SWP CROSS DRAINAGE EAST BRANCH Mile Post 303.9 to Mile Post 403.4 HYDROLOGIC & HYDRAULIC DATA TABLE B-5

STATE WATER FACILITIES
CALIFORNIA AQUEDUCT
MOJAVE DIVISION

CANAL STA. 1+64.10 TO STA. 955+91.27
STA. "P" 0+00 TO STA. "P" 29+00
TAPERED TRIPLE BOX CULVERT
STA. 151+40 PLAN AND SECTION
DRAINAGE PLAN STA. 143+00 TO STA. 175+00

Riverine Systems near SCH No. 20241000

PLAN AND PROFILE
STA. 165 + 00 TO STA. 220 + 00

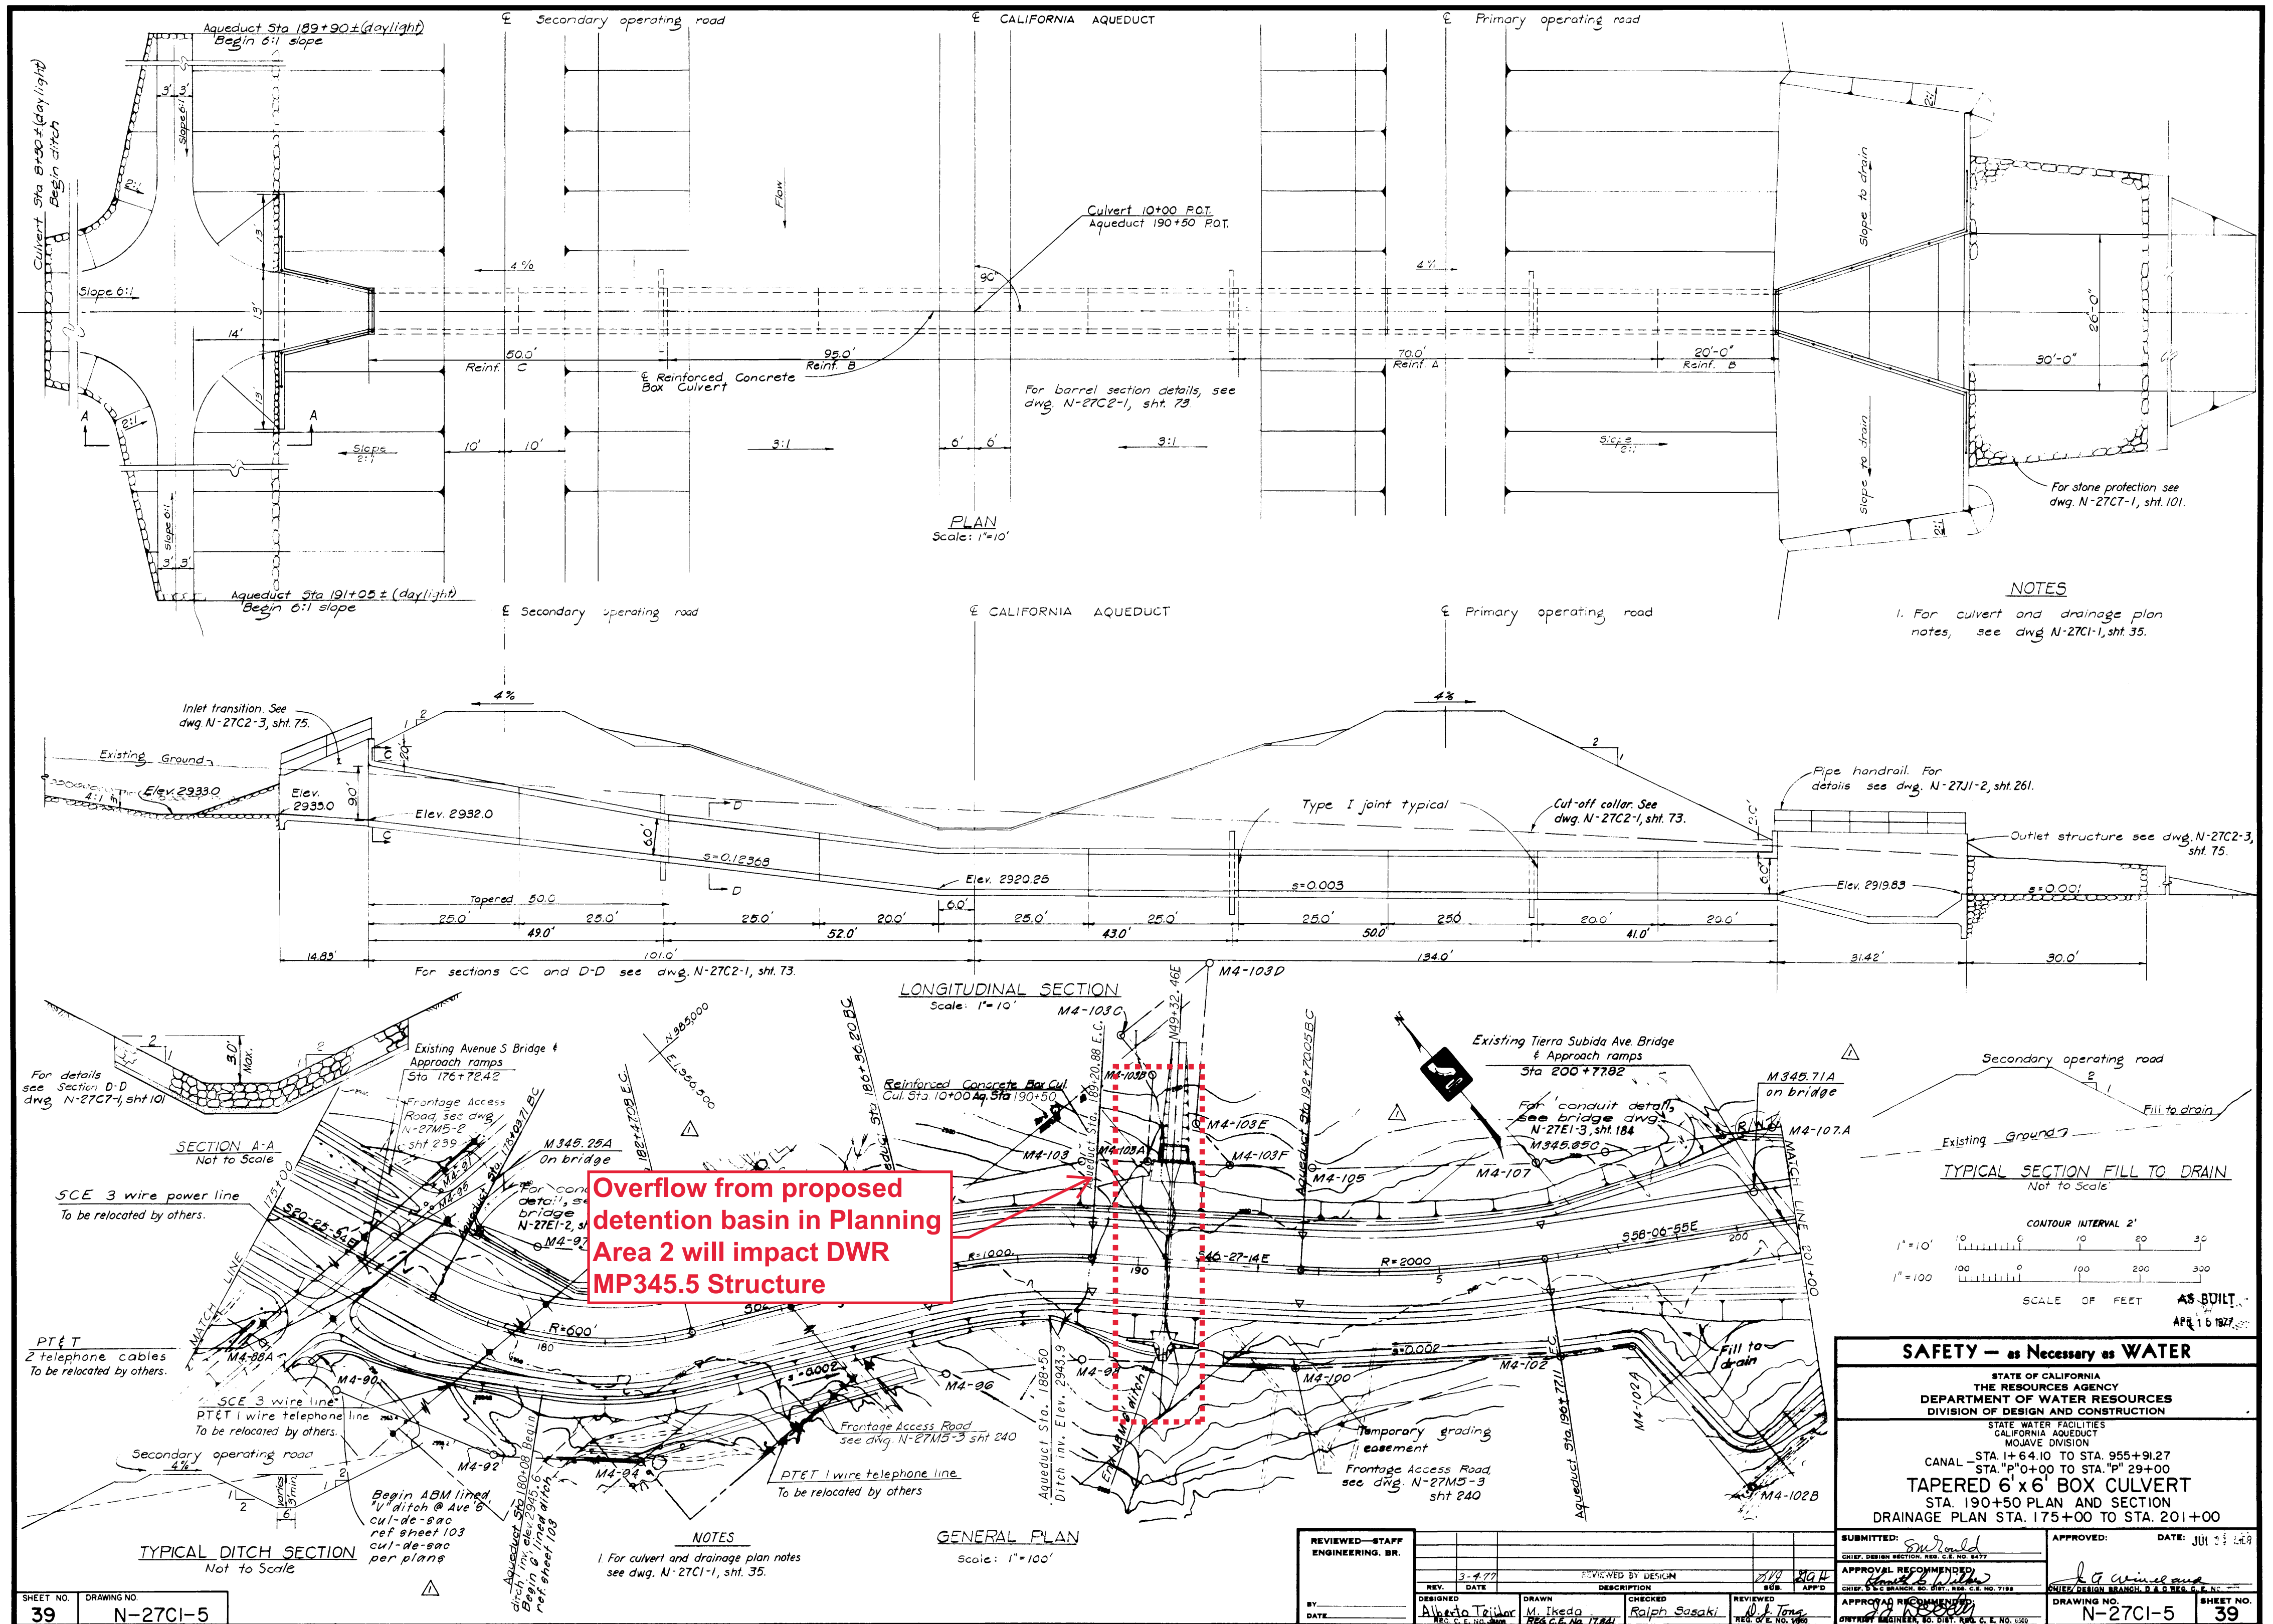
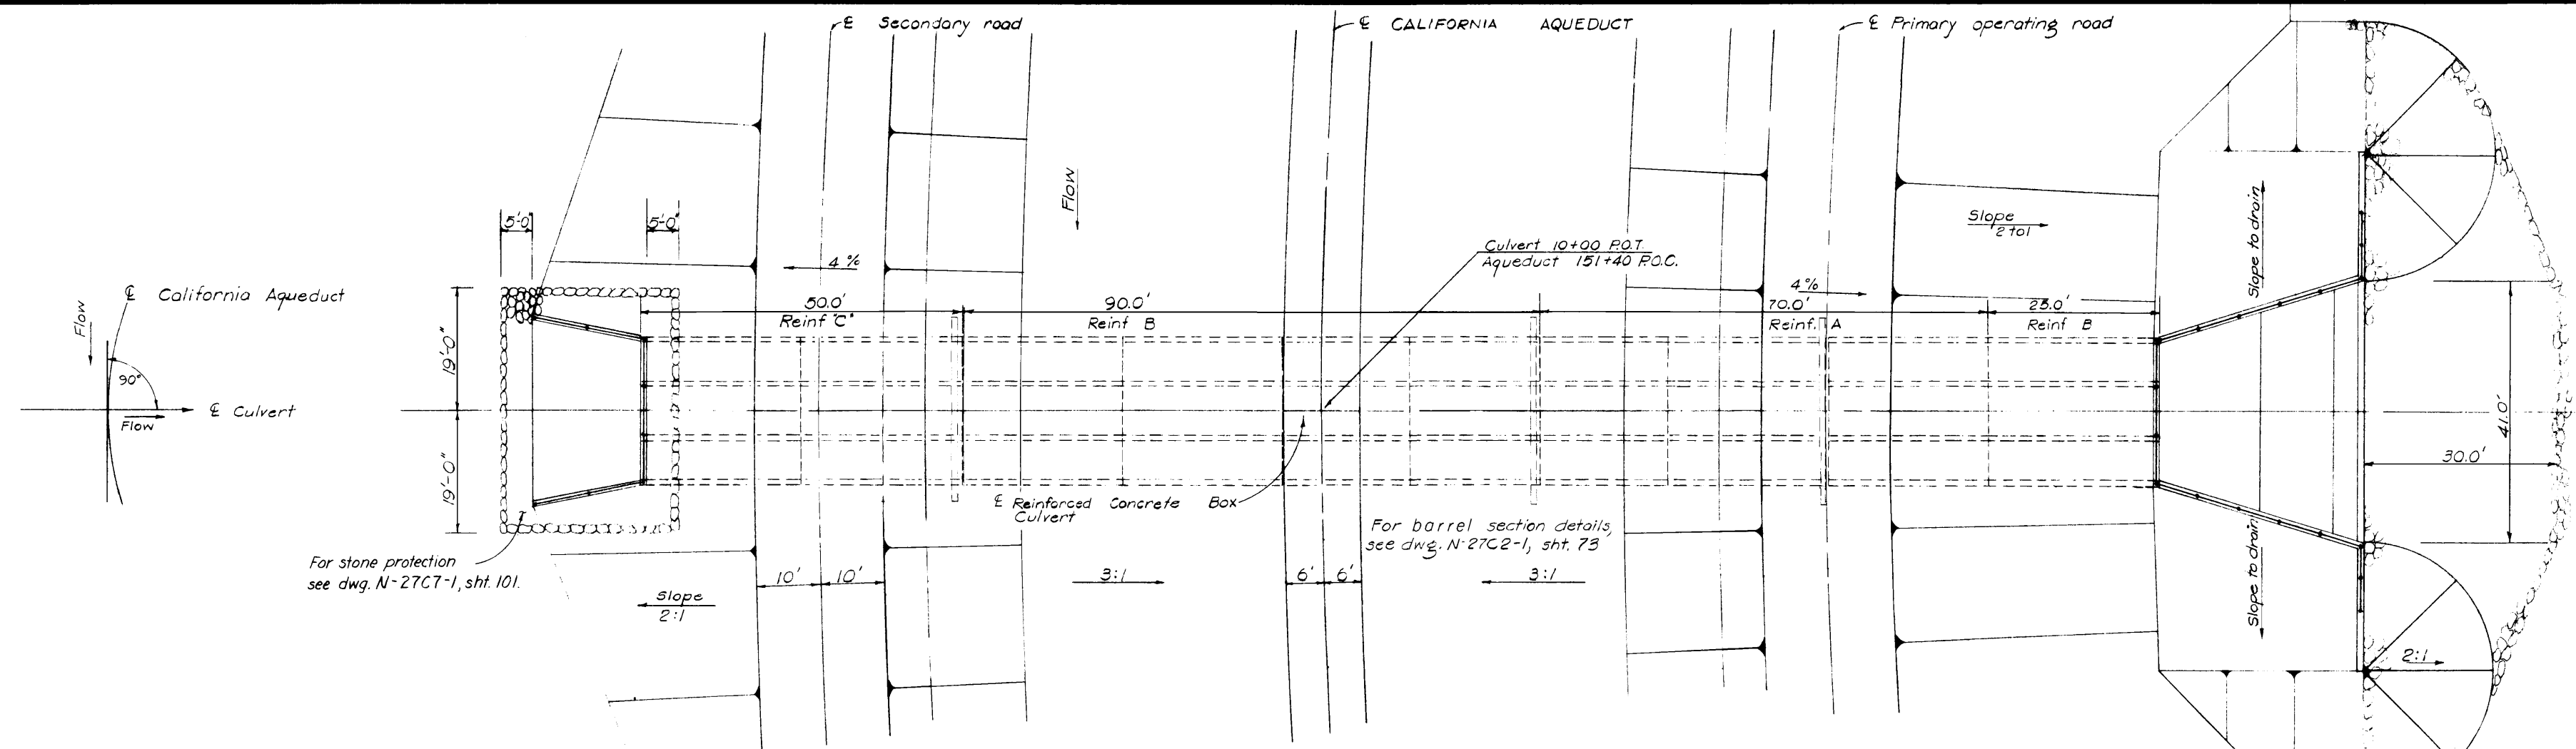
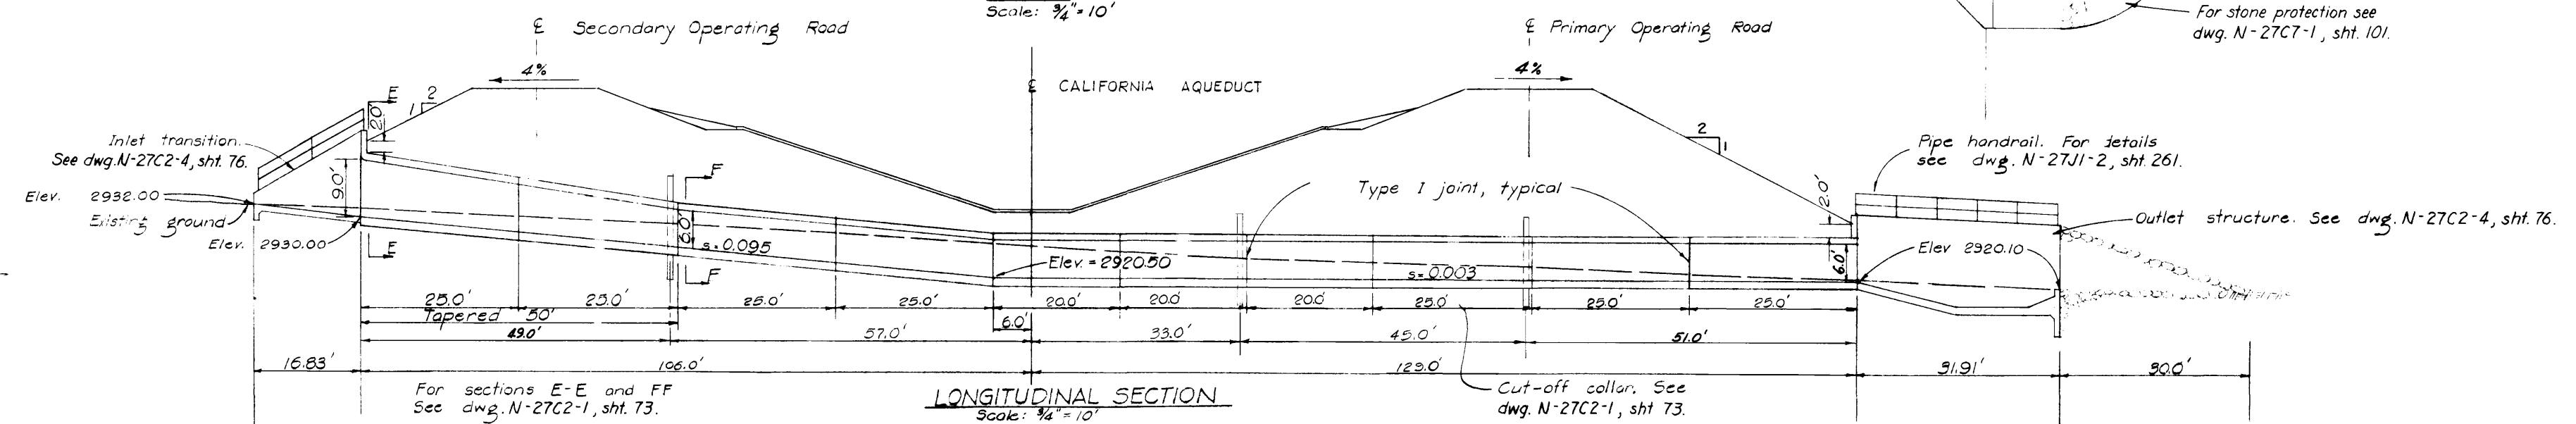
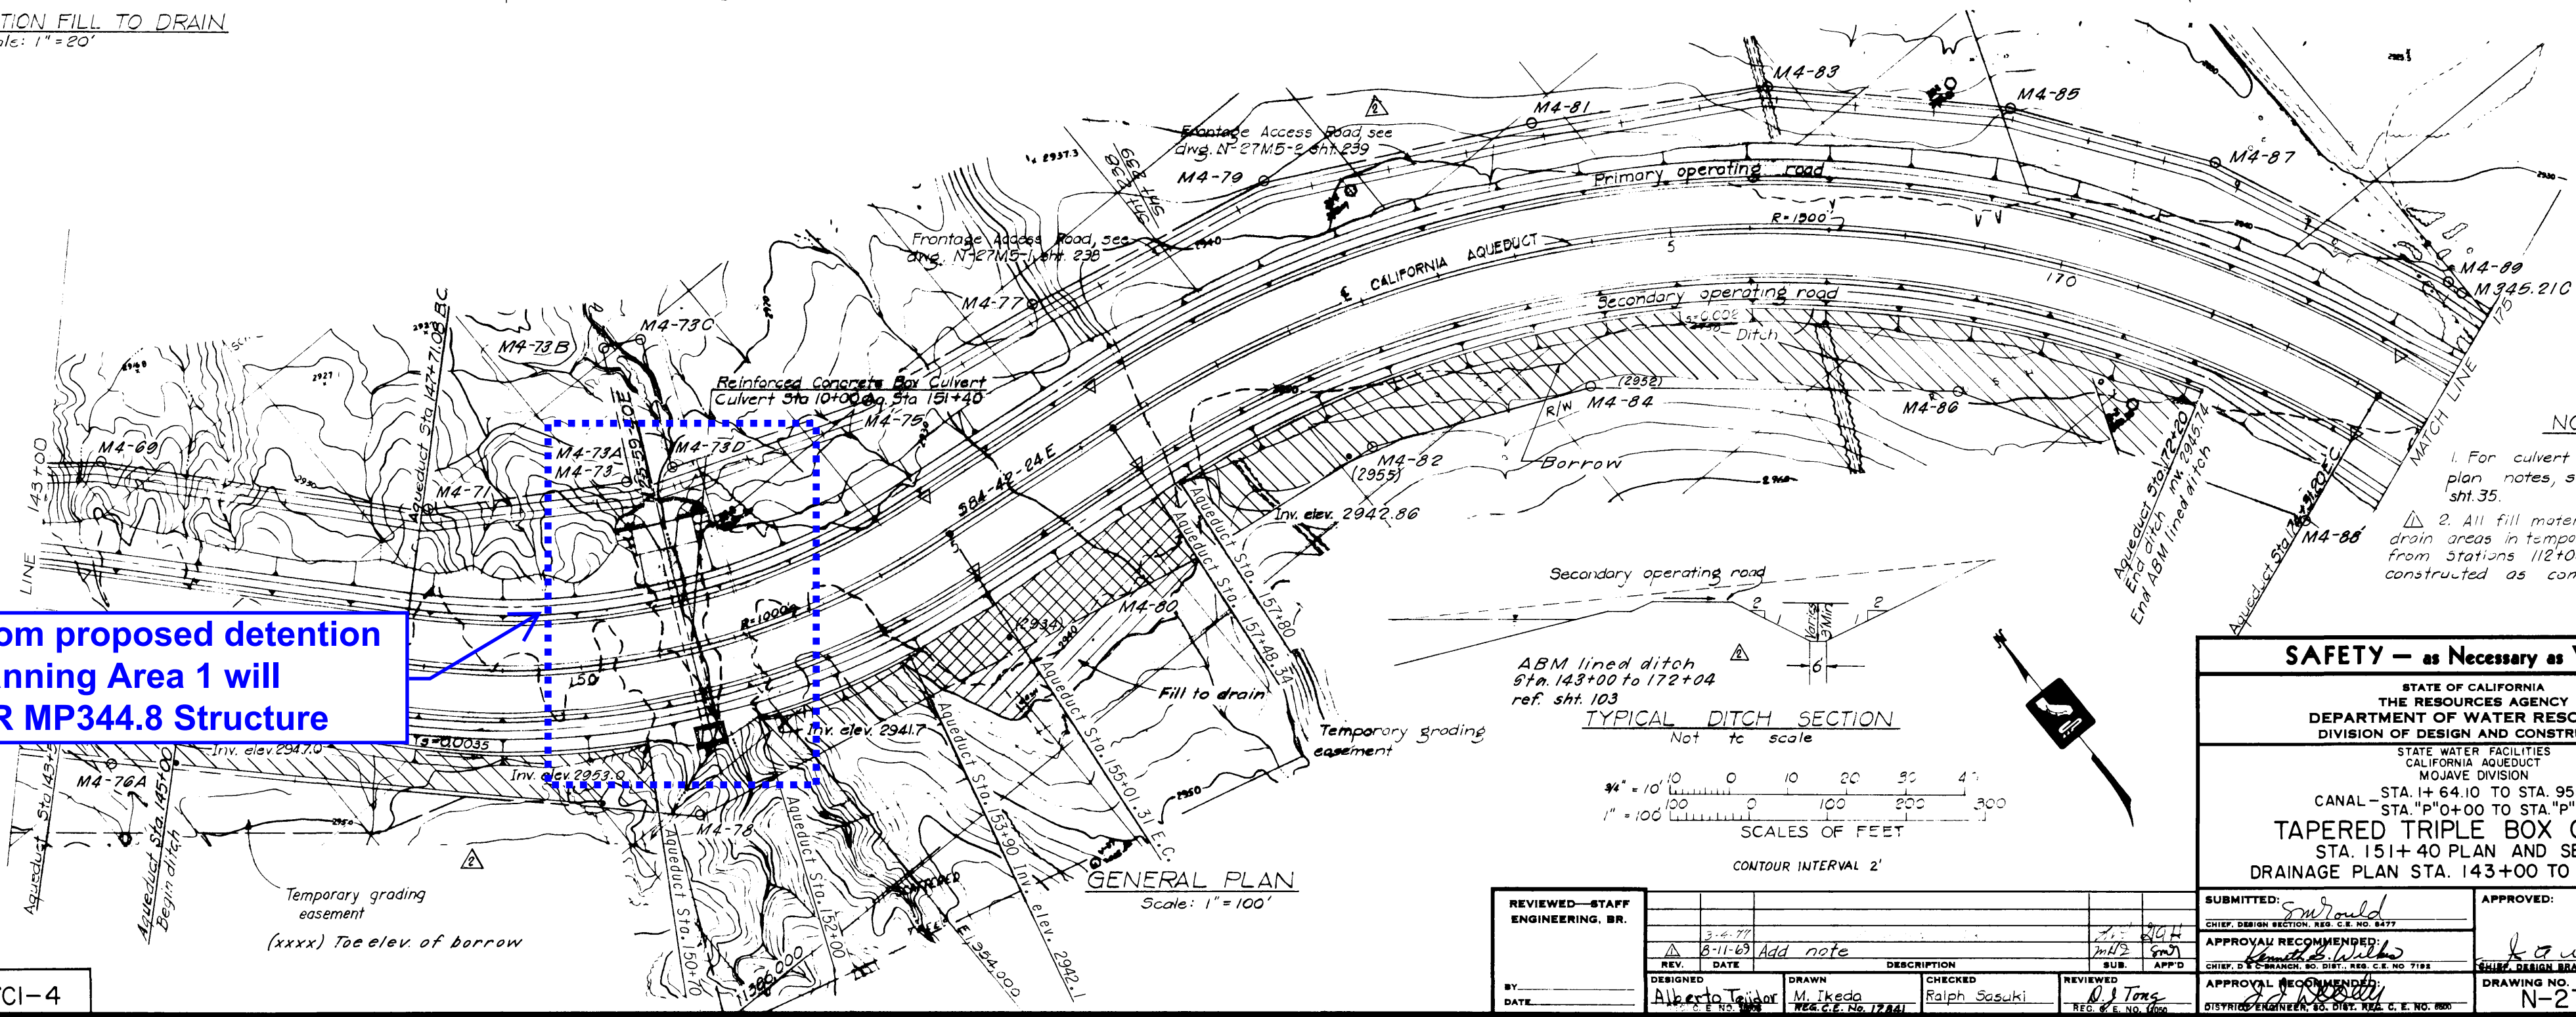
Overflow from proposed detention basin in Planning Area 1 will impact DWR MP344.8 Structure
